**ADDENDUM #3**

FOR: ITB-003-2019  
JET-A 15,000 GALLON FUEL TANK AND SKID SYSTEM

The purpose of addendum #3 is to provide answers to questions received to date, to add and additional item to the specifications and to provide further clarification of the skid system we require.

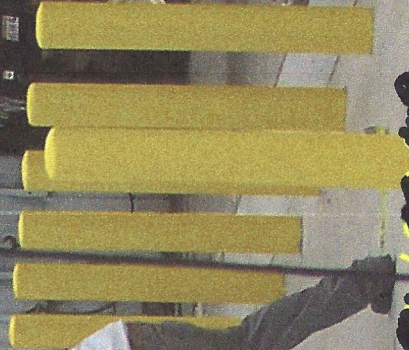
2. Should the tank and equipment be mounted to steel beam frame with a larger shed over the equipment.  
**Answer: Please see attached examples for the skid system required.**
